STATE OF NORTH CAROLINA
DEPARTMENT OF TRANSPORTATION

Subject: Modification request for Section 404 Nationwide Permits 12 and 14 and Section 401 Water Quality Certification for the construction of the US 401 improvements in Fayetteville, Cumberland County TIP No. U-4405. Debit \$570 from WBS 39049.1.1.

Reference: Section 404 USACE Action ID. SAW-2011-01806, issued December 1, 2017
Section 401 NCDWR Project No. 20171365, issued November 15, 2017

PERMIT DRAWING
SHEET 16 OF 18

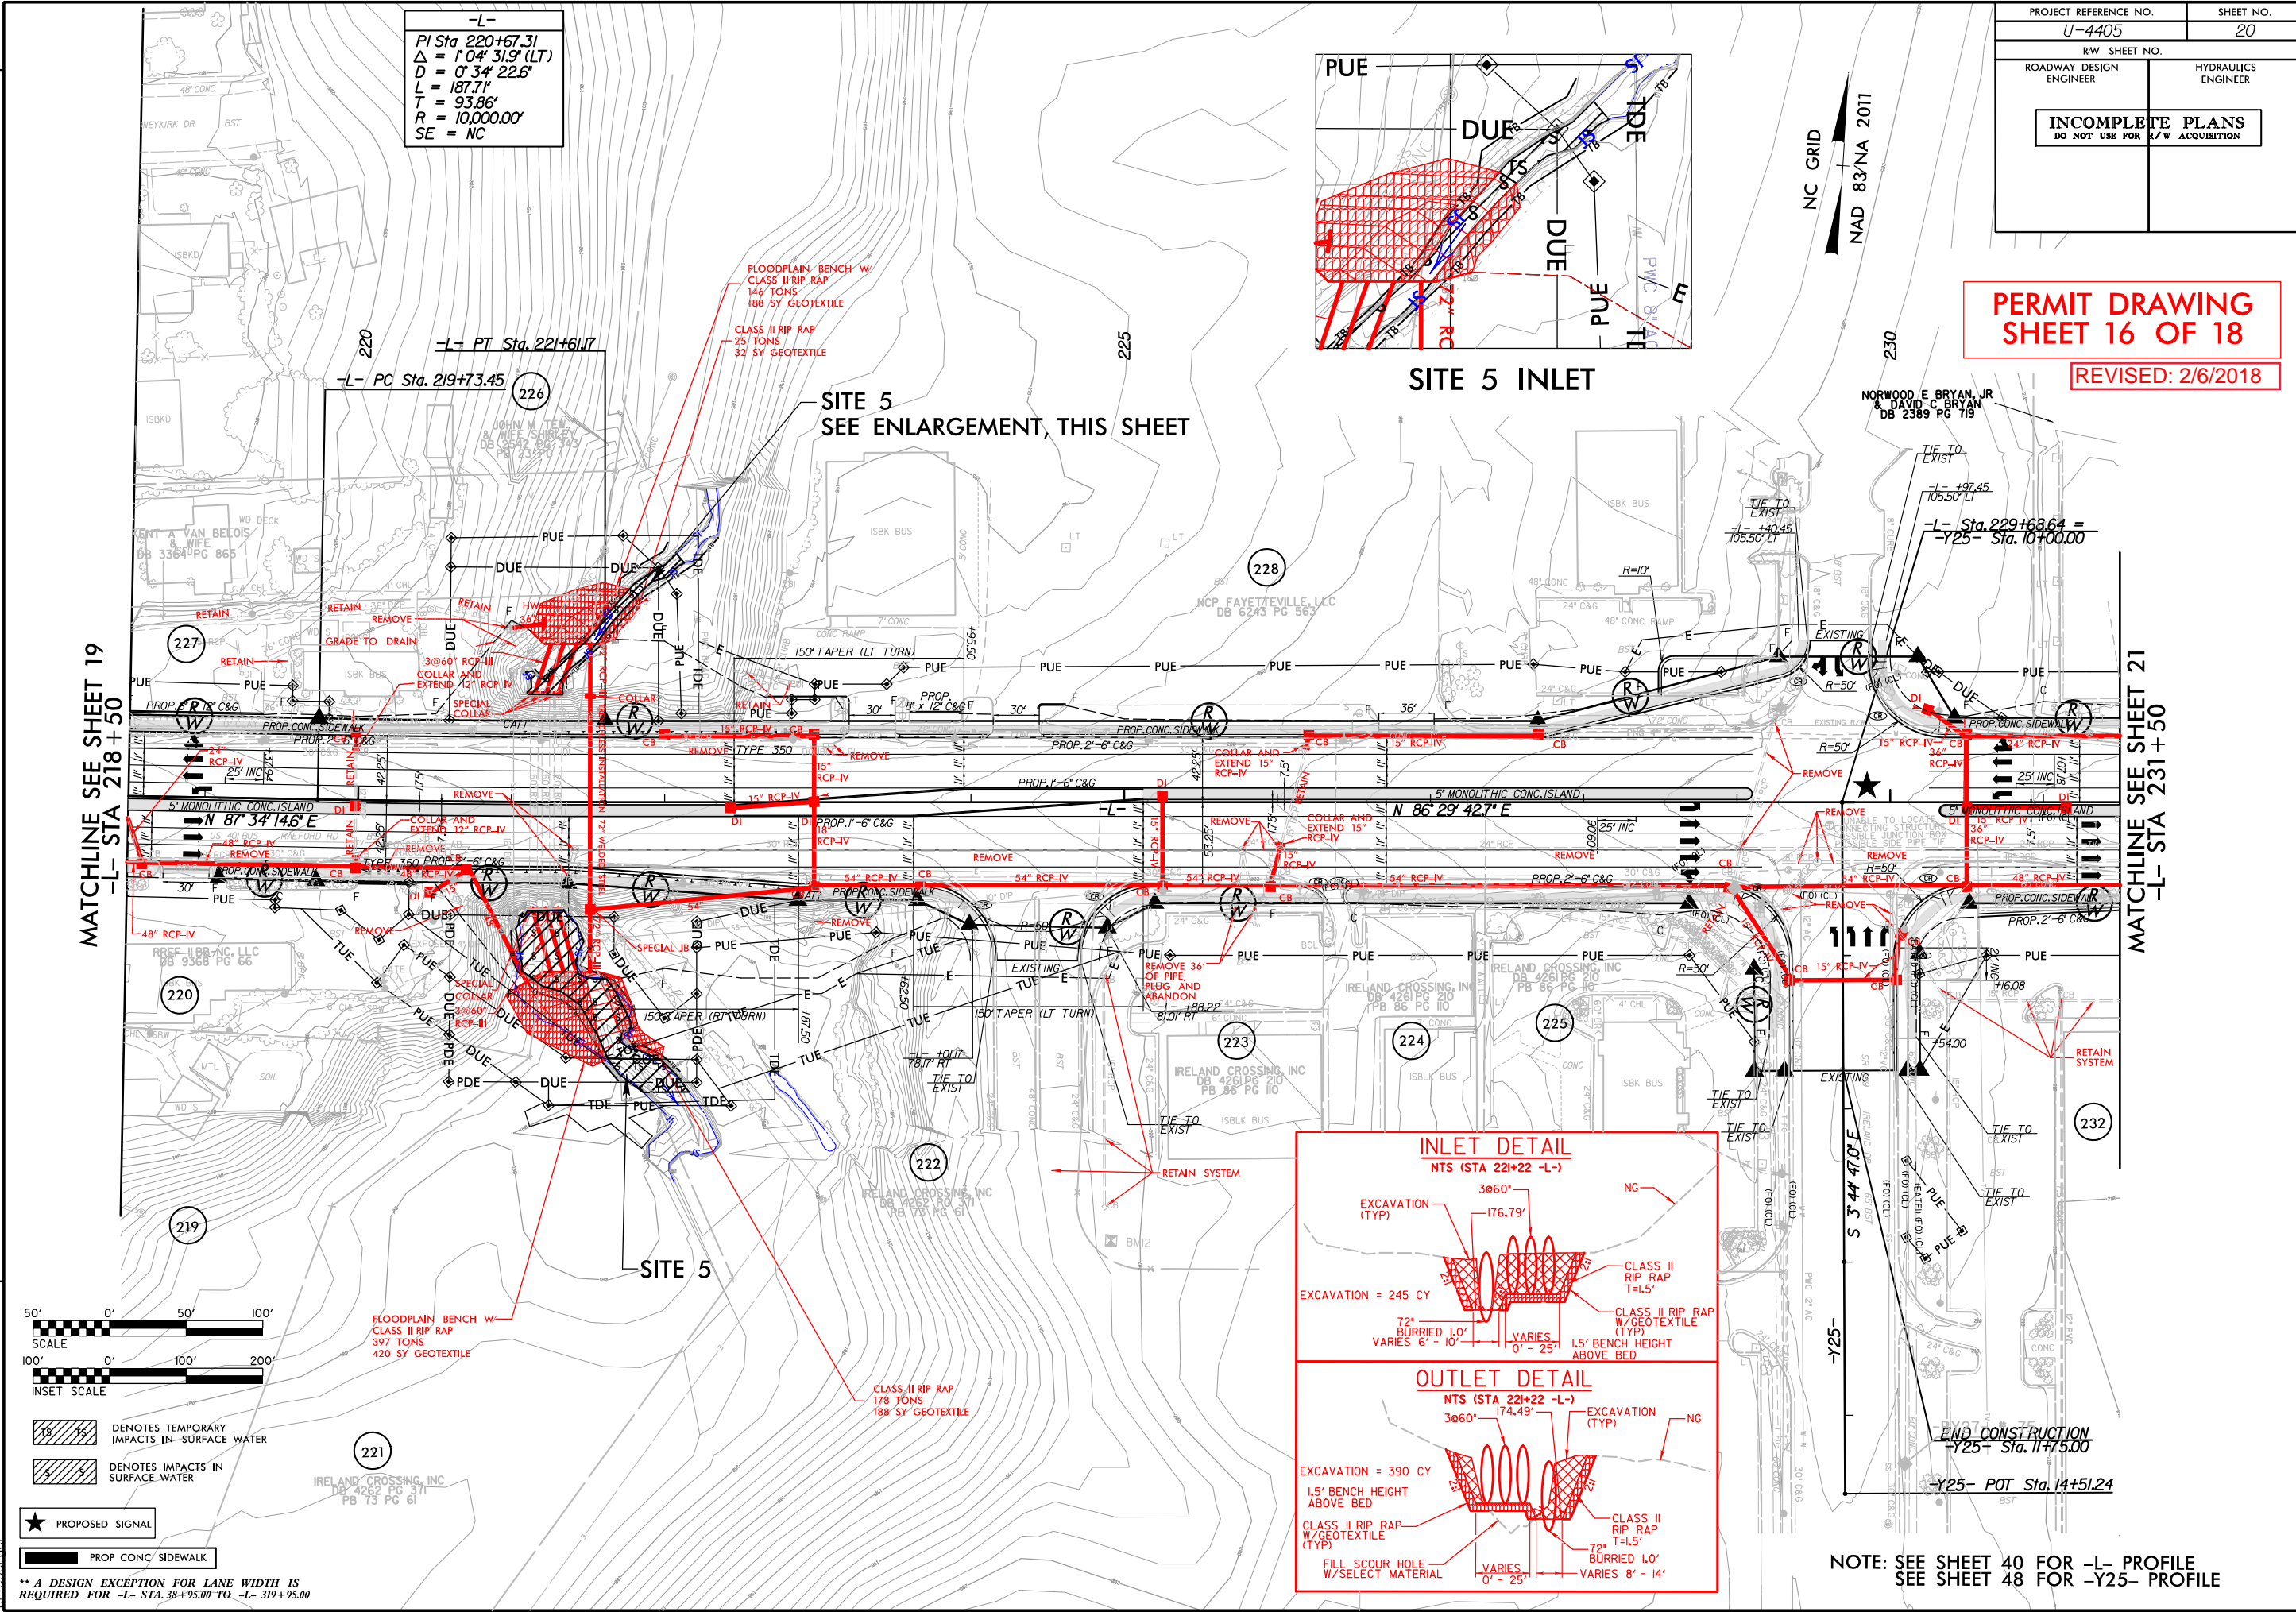
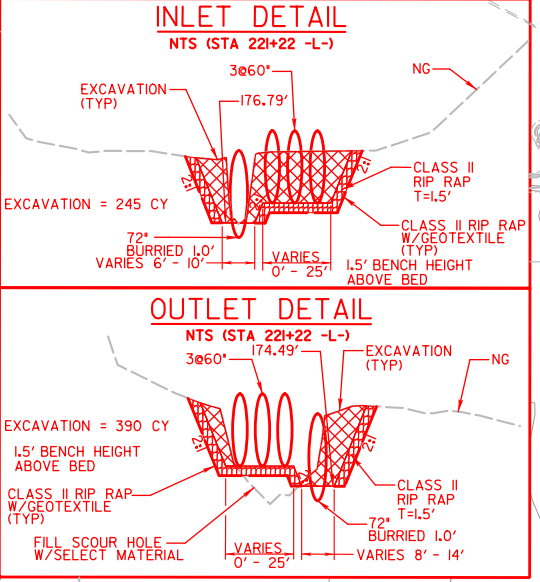
Site 5: The temporary stream impacts were extended on the upstream end (previously stopped just inside the DUE, now extends between the DUE and TDE) and shortened on the downstream end (previously extended to area between DUE and TDE, now stops inside of DUE area). Temporary surface water impacts increased to 0.02 ac.
